Document 5D/119-E

Source: Attachment 6.11, Chapter 6 of Doc. 5D/97 (Source: Doc. 5D/TEMP/28) English only Institute of Electrical and Electronics Engineers (IEEE) PROPOSED CHANGESS TO SECTIONS 5 AND 6 OF THE ITU-R/ IMTADVANCED/IMT.TECH DOCUMENT AS PRESENTED IN DOCUMENT 5D/TEMP/28

Proposed amendments to Section 5_

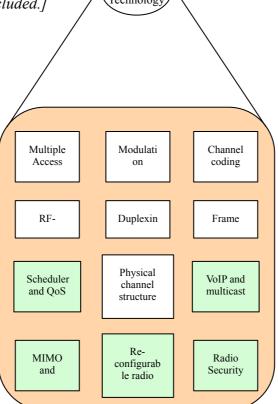
[Included diagram below from Doc. 8F/12 (Transmission a) as a placeholder, to be updated when subsections in 2.1 are concluded.]
